**FINAL DRAINAGE REPORT
FOR
ABTR STORAGE
UNPLATTED
415 N FRANCEVILLE COAL MINE ROAD
COLORADO SPRINGS, COLORADO**

MARCH 2023

Prepared By:
TERRA NOVA ENGINEERING, INC.
721 S. 23RD Street
Colorado Springs, CO 80904
719.635.6422

PPR2319

Pipe ID: **Existing Road Culvert**

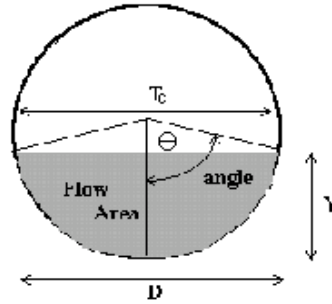
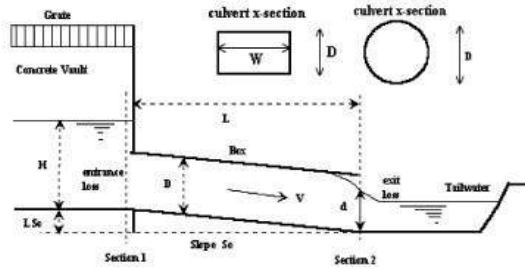
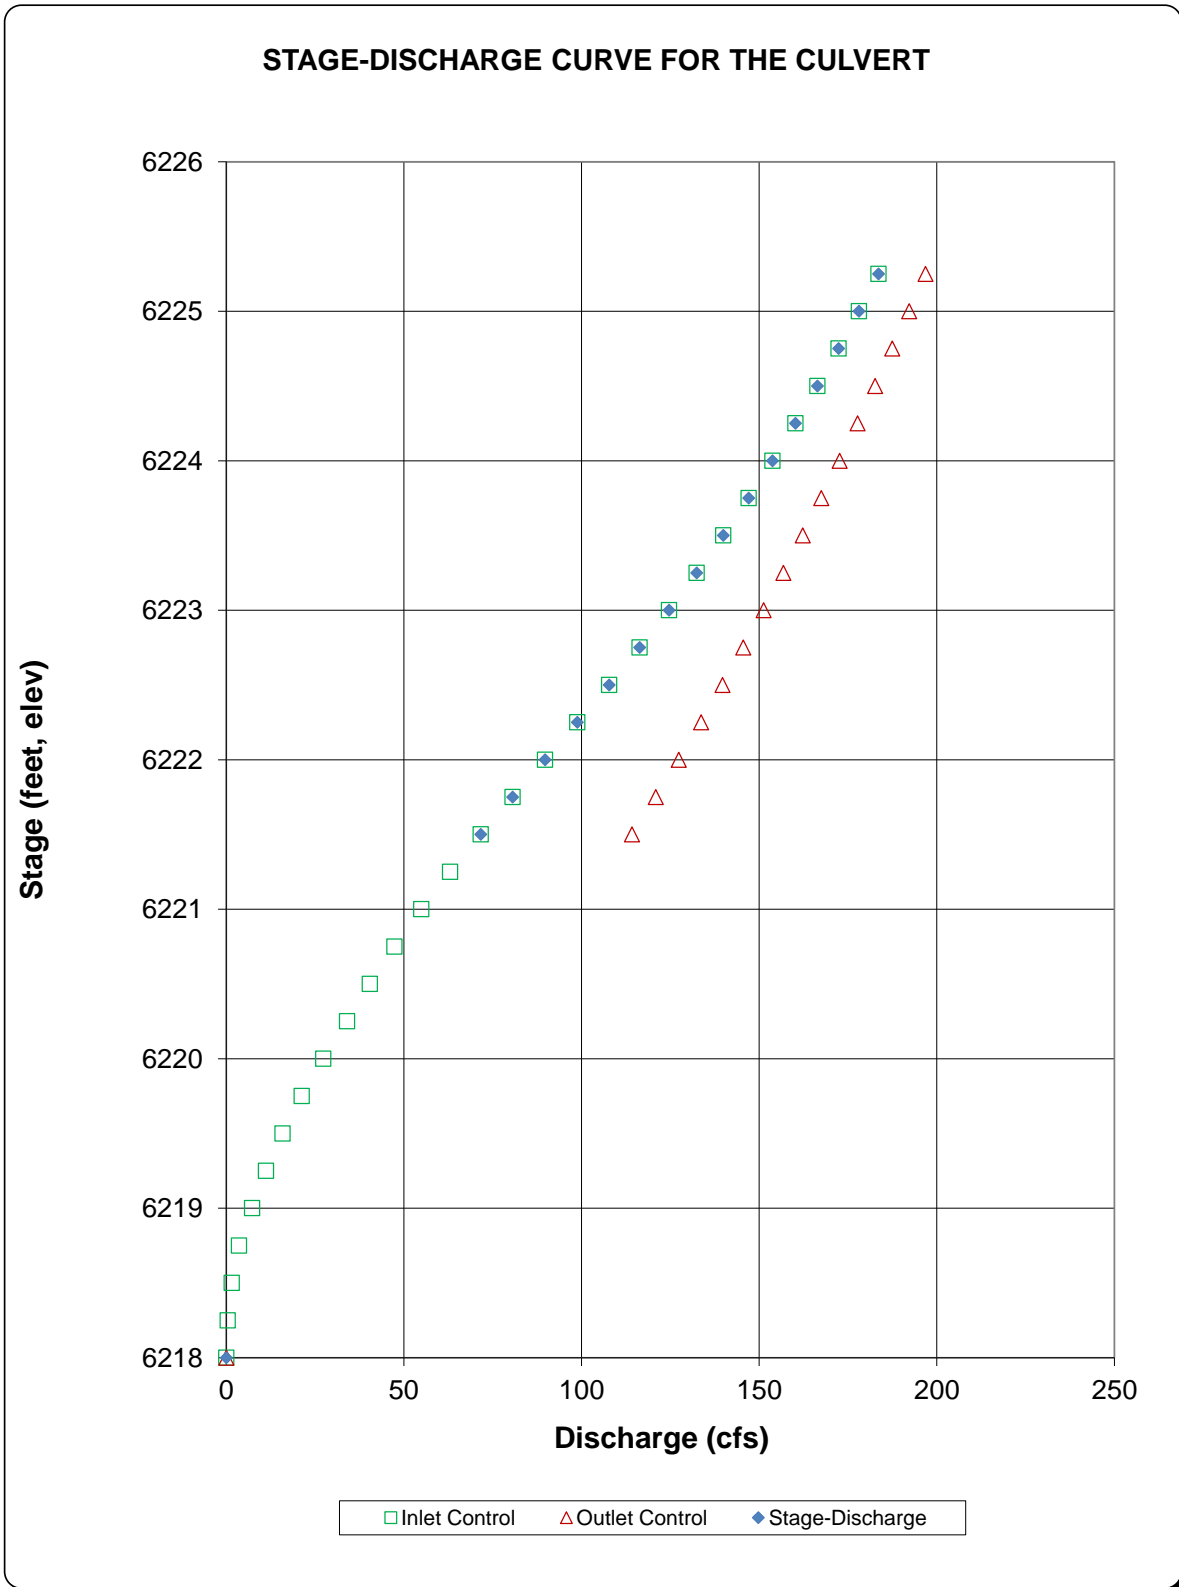
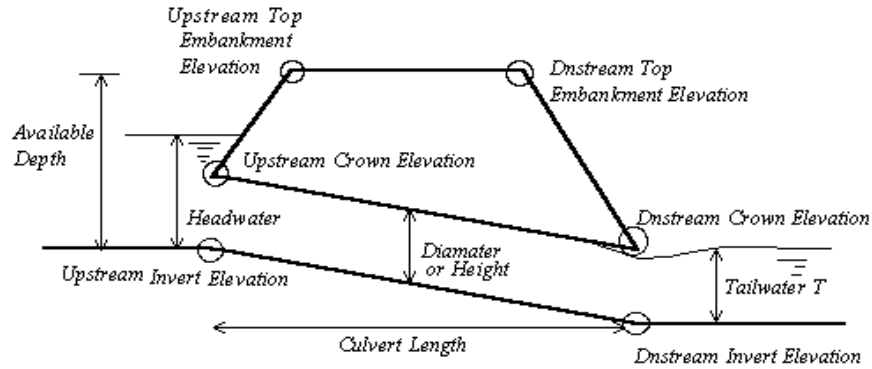
Revise to include any recommendations for culvert. Include whether it meets criteria for overtopping per DCM table 6-1. Per ECM 3.2.4 a suitable outfall is required for developed flows.

DETENTION BASIN OUTLET STRUCTURE DESIGN

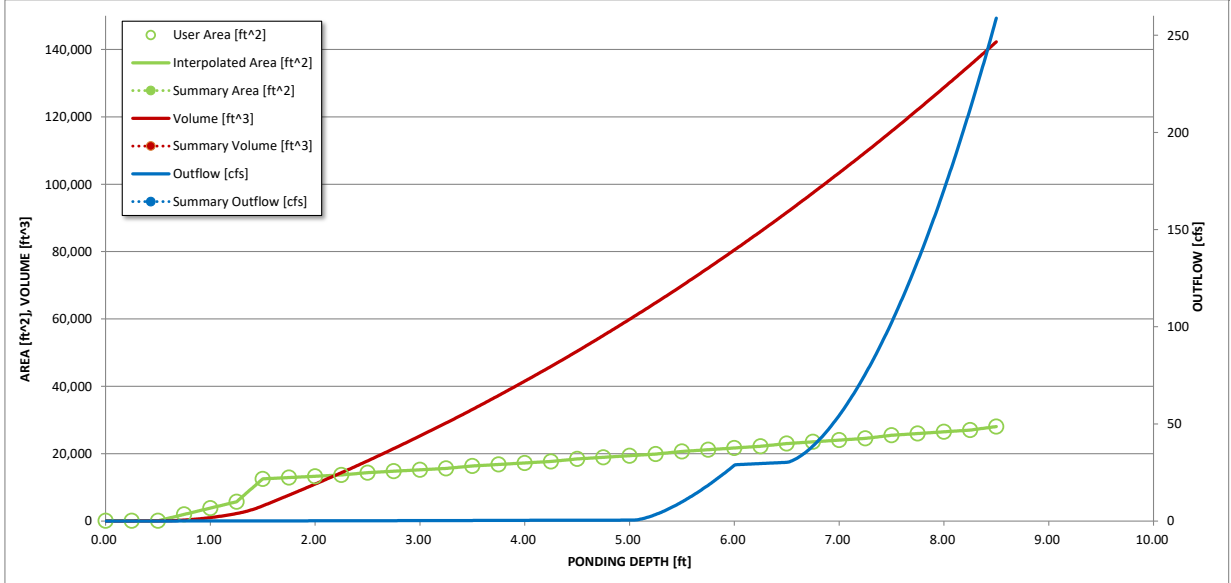
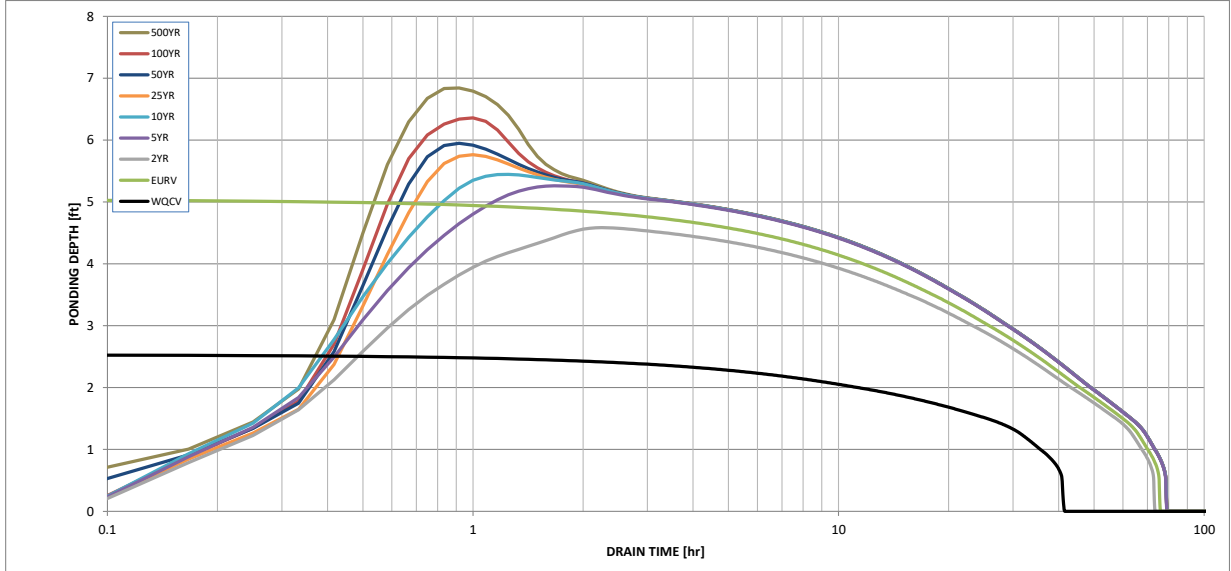
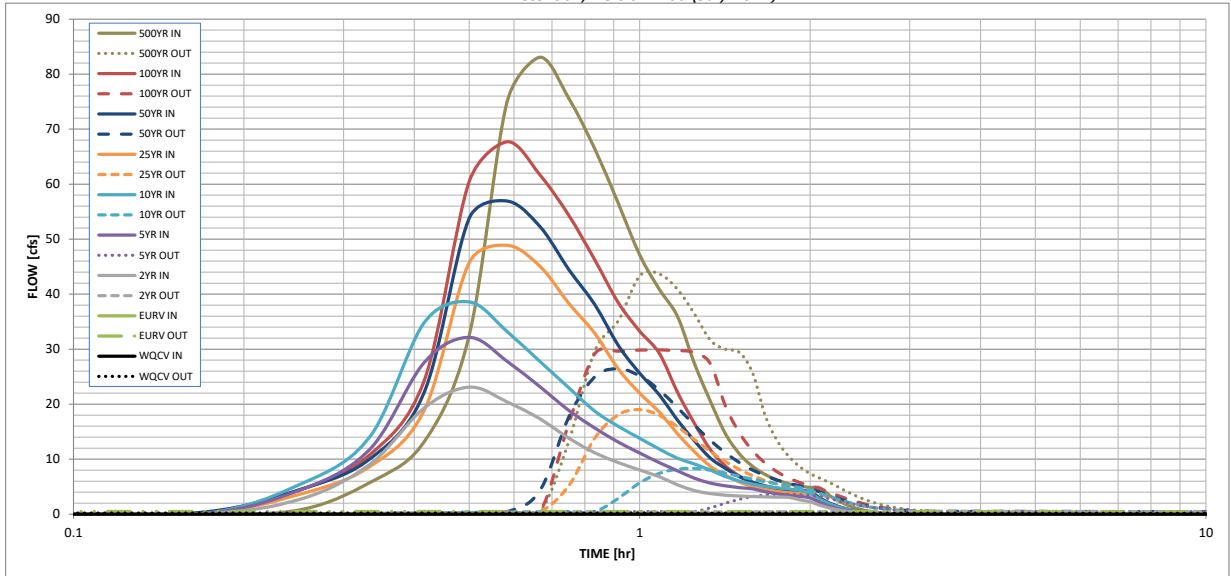
Watershed imperviousness should be higher based on land coverage draining to pond. Revise and provide calculation for how impervious value was determined.

15/16in diameter is actually A=0.69 sq in. Revise calcs and plans accordingly.

DETENTION BASIN OUTLET STRUCTURE DESIGN

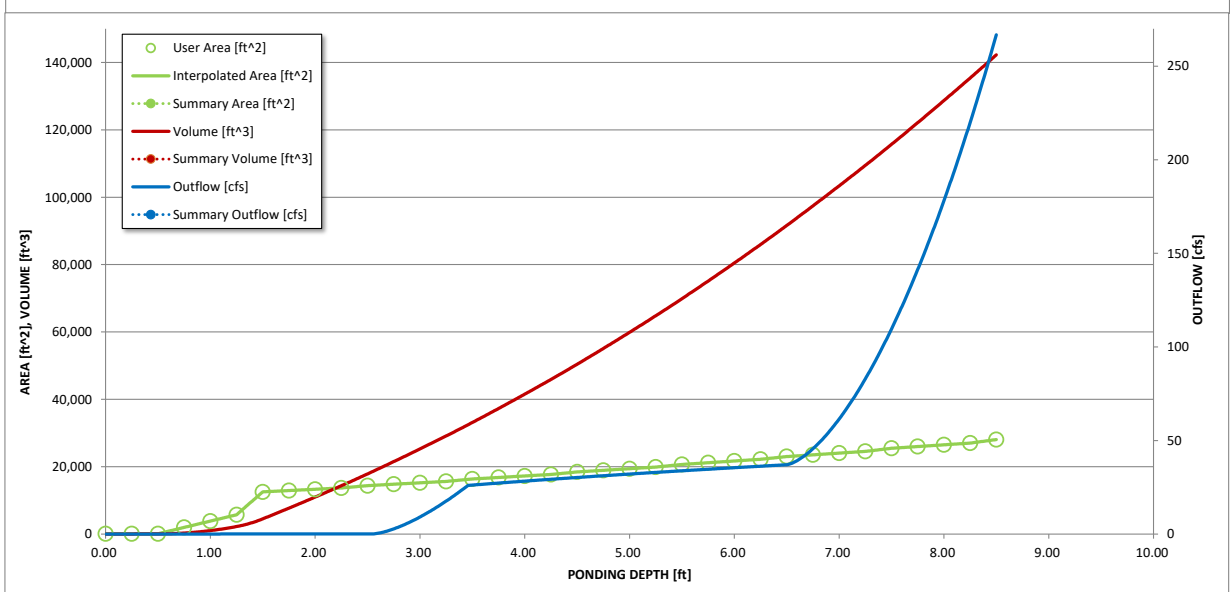
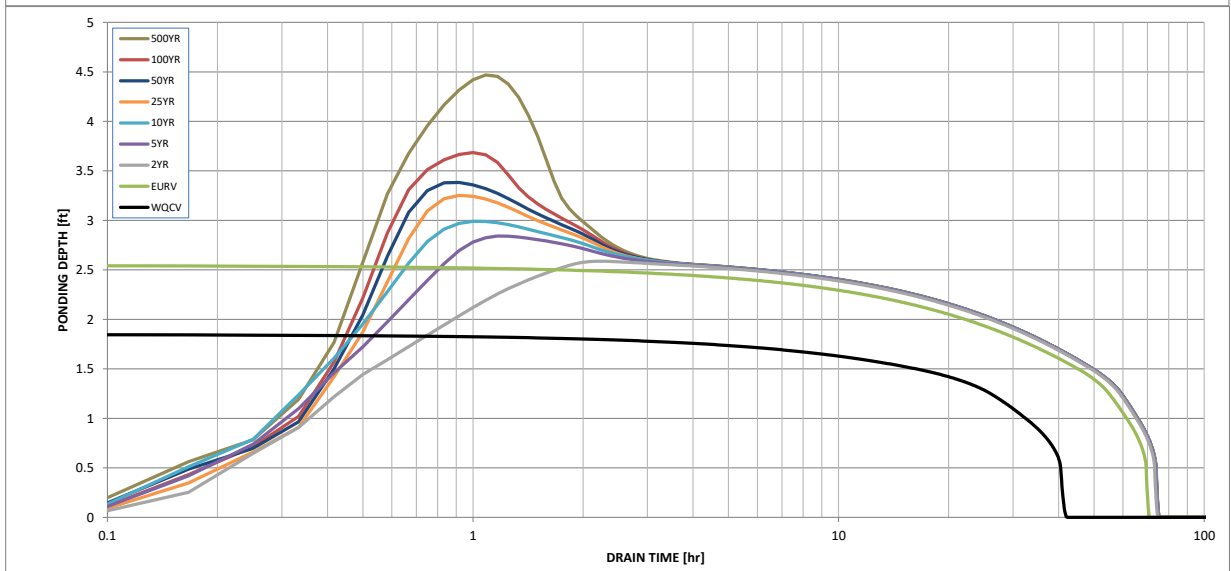
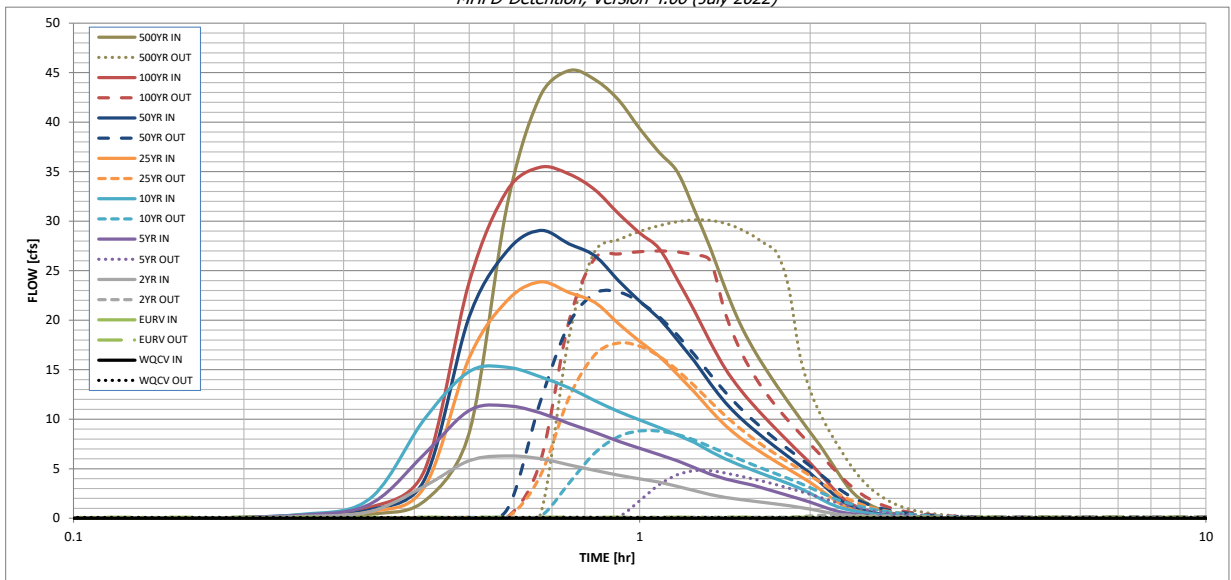
Correct value to 97% Recalculate

1in diameter is actually A=0.785 sq in. Revise calcs and plans accordingly.

EXISTING DRAINAGE MAP

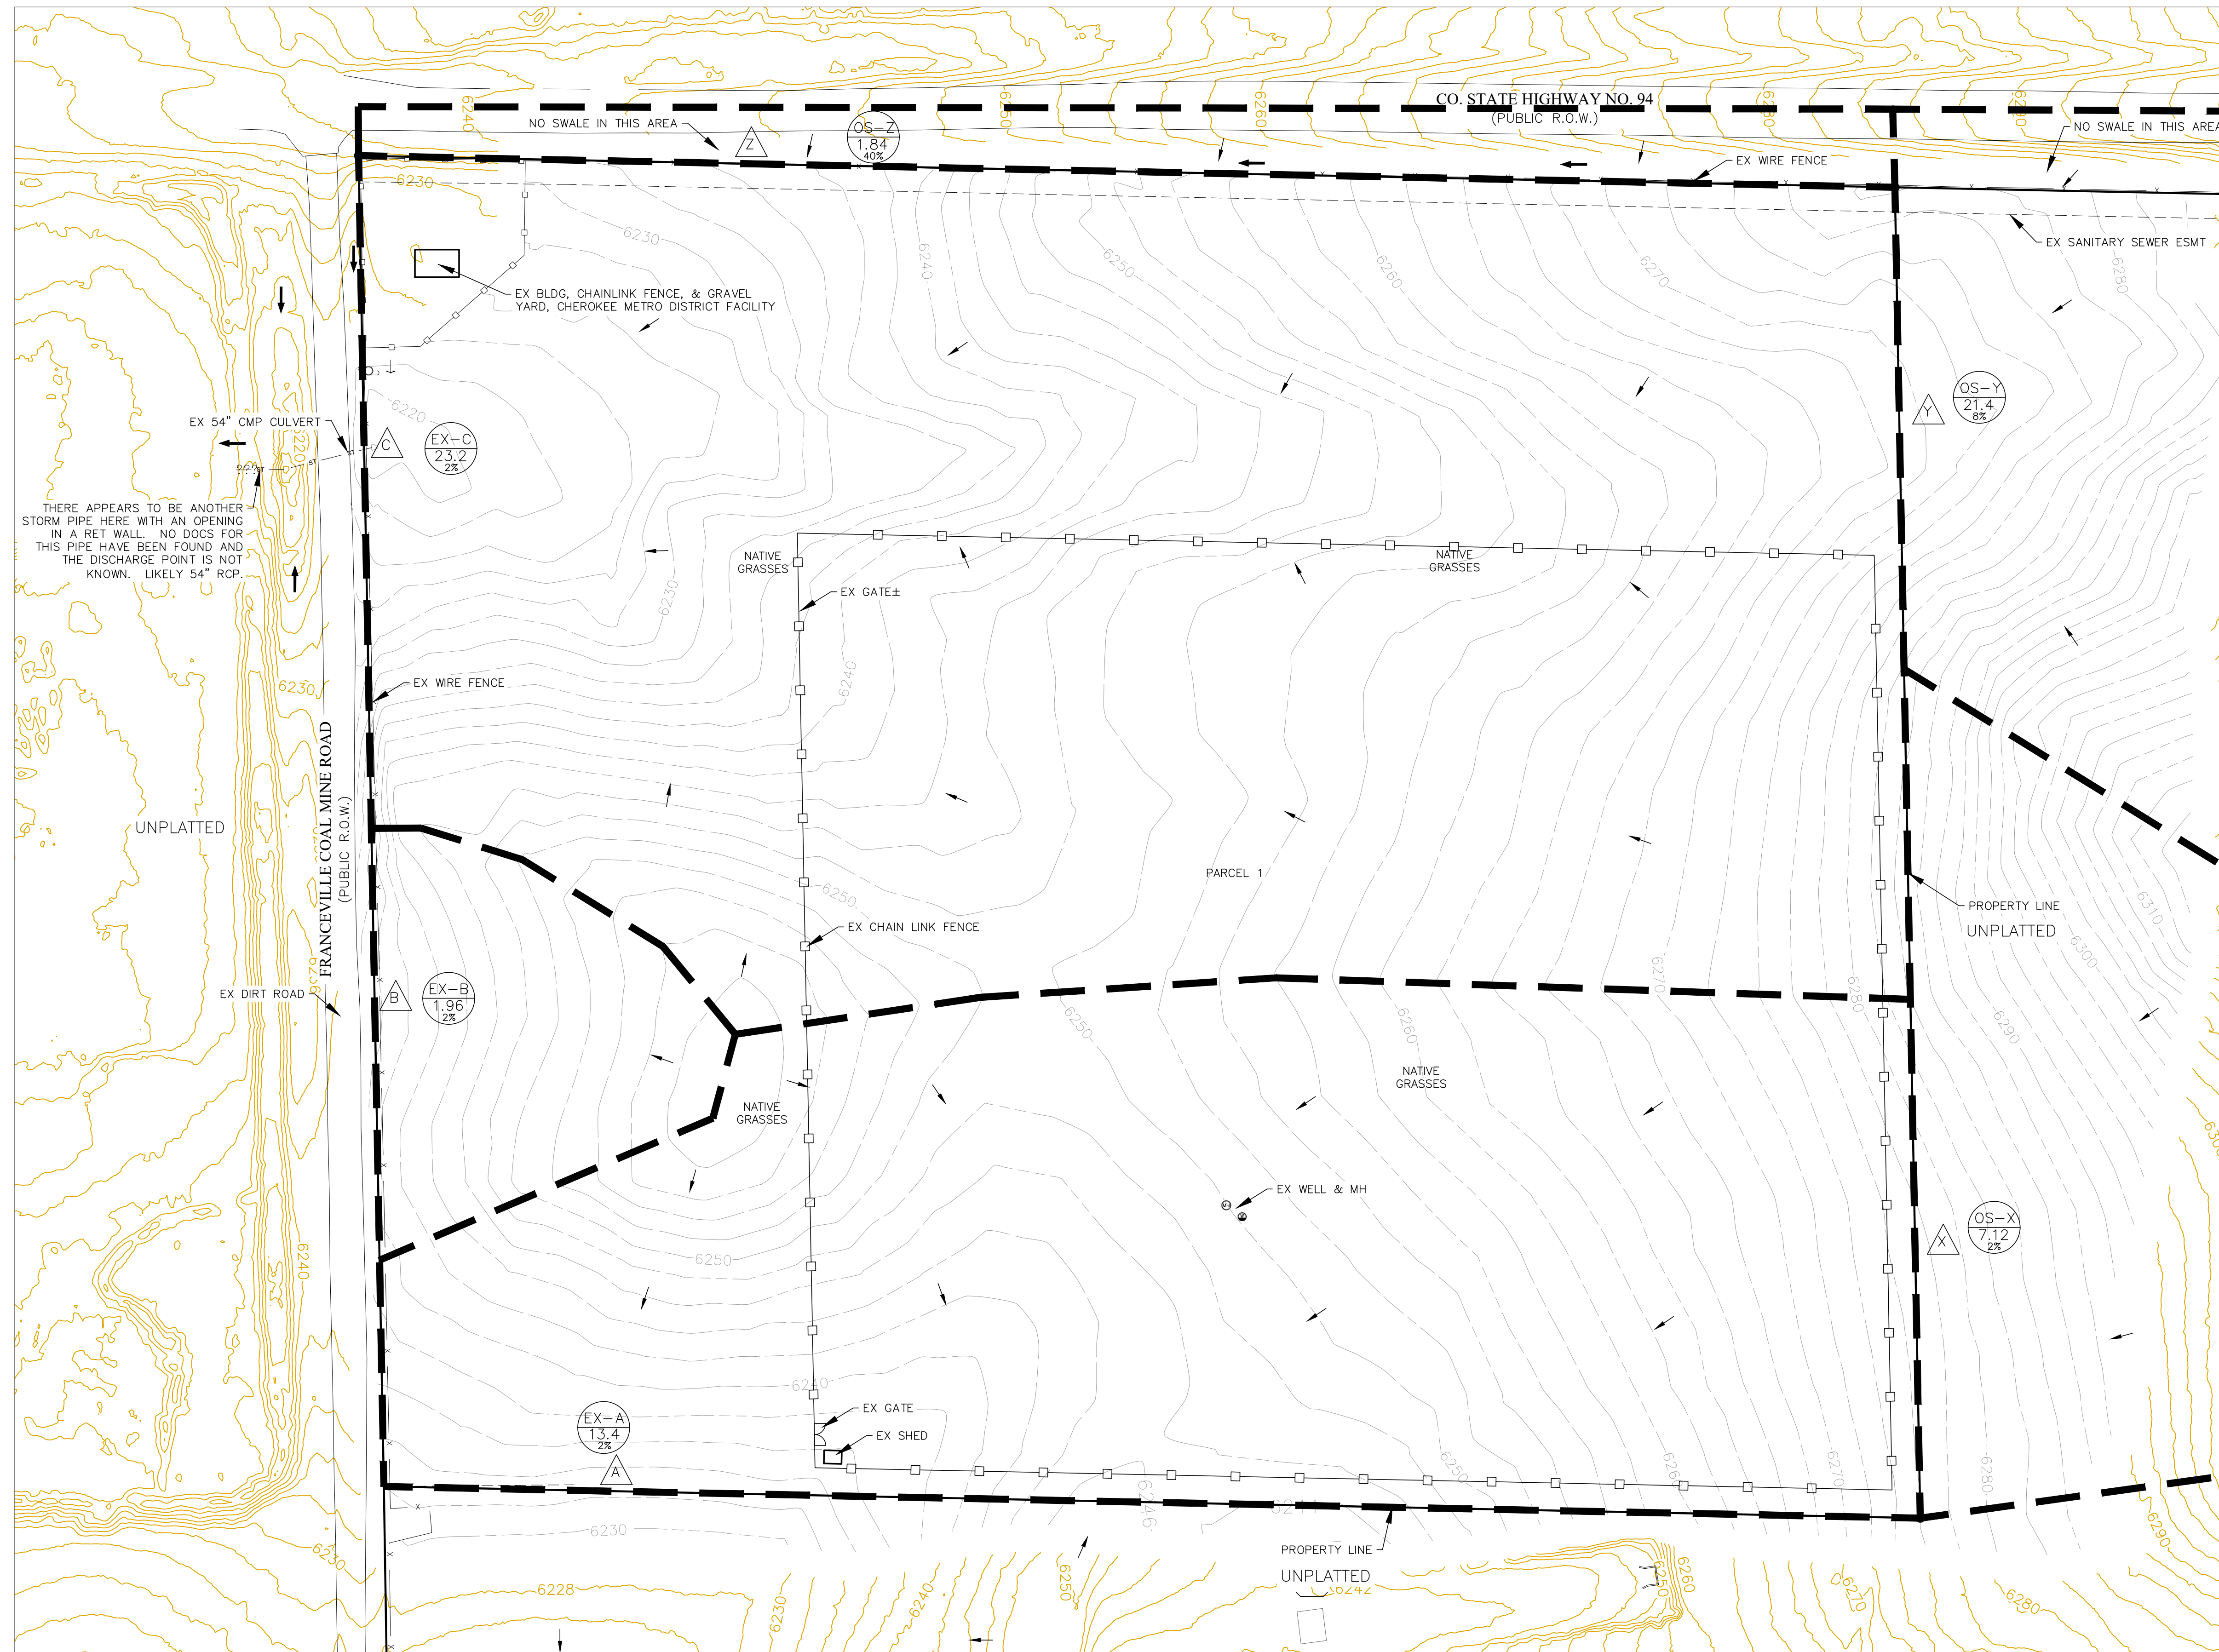
Provide a summary table for the design points shown on the drainage map.
